Subject: Review of revised IM—Effects of Environmental and Metallurgical Conditions on the Passive and Localized Dissolution of Ti-0.15Pd, Intermediate Milestone 01402.571.010

Reference: Letter from T. Ahn to V. Jain, April 12, 2001: Acceptance of Intermediate Milestone 01402.571.010 "Effects of Environmental and Metallurgical Conditions on the Passive and Localized Dissolution of Ti-0.15Pd"

EFFECTS OF ENVIRONMENTAL AND METALLURGICAL CONDITIONS ON THE  
PASSIVE AND LOCALIZED DISSOLUTION OF Ti-0.15Pd

Porossia & Craynolds, Figure 10

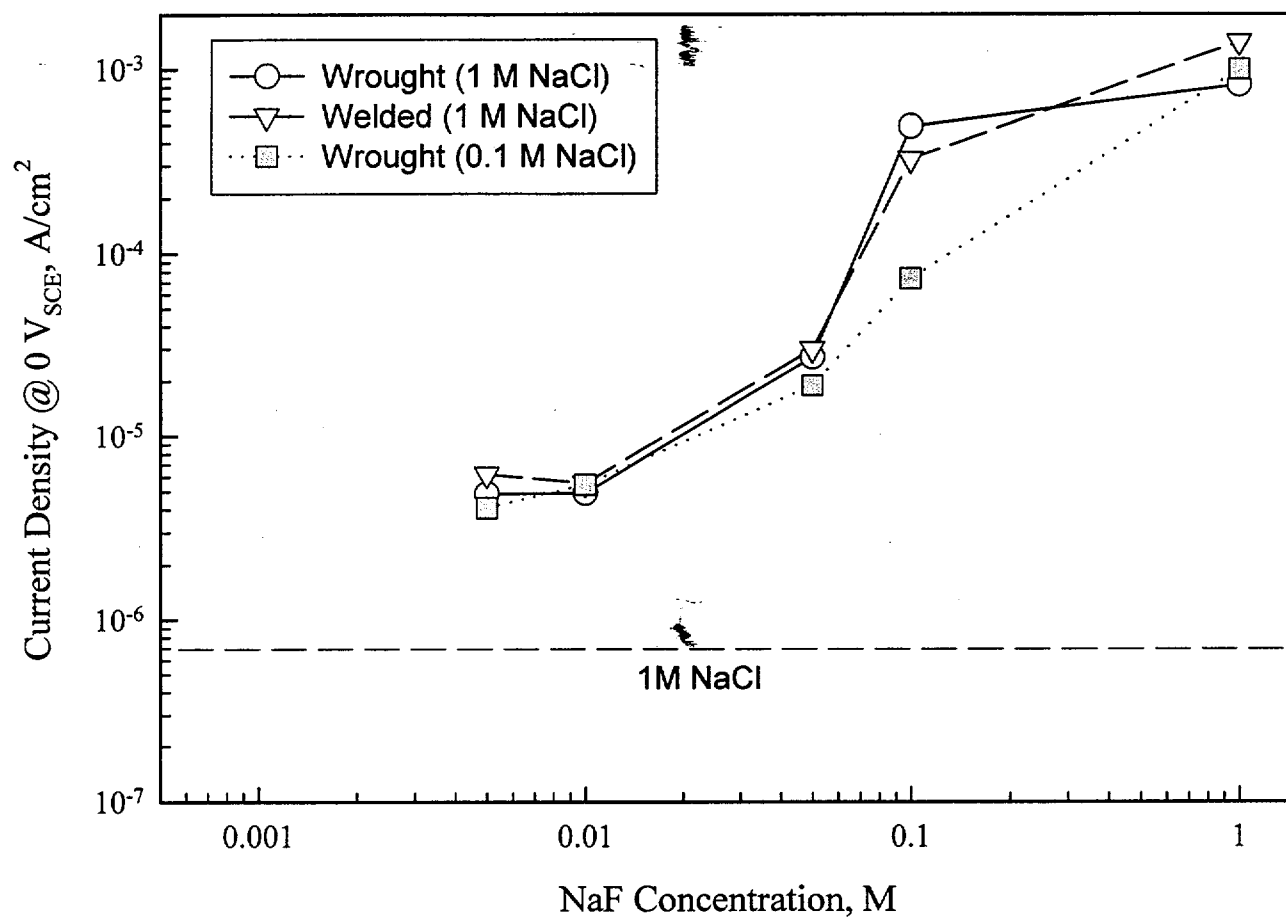
- (1) **Clarify on page 8, there are 4 solutions listed in reference to figure 9 that has 3 curves; the paragraph starting with "Also" states 2 dashed lines referenced in figure 9 that has no dashed lines.**

Accept. This has been clarified in the test.
